Technical product information

Topic	Bentayga front door trim - Alignment pin
Market area	Bentley: worldwide (2WBE)
Brand	Bentley
Transaction No.	2062338/1
Level	EH
Status	Approval
Release date

Figure 1

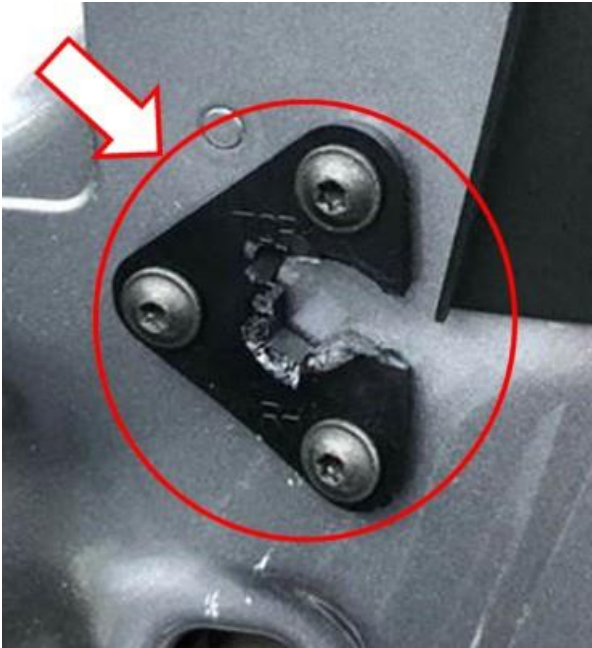
The alignment pin used to locate the front door trim panel is broken (Figure 1)

▪ The front alignment pin is required to aid alignment of the door trim panel to the door panel during the Manufacturing process

NOTE: In Service the alignment pin is not required

Referring to Figure 1 – Remove and discard the following:

- Broken alignment pin x1 (If evident)
- Fixings x3
- Alignment pin plate x1

TIP: Cover the area in which the plate was previously fixed using anti creak tape
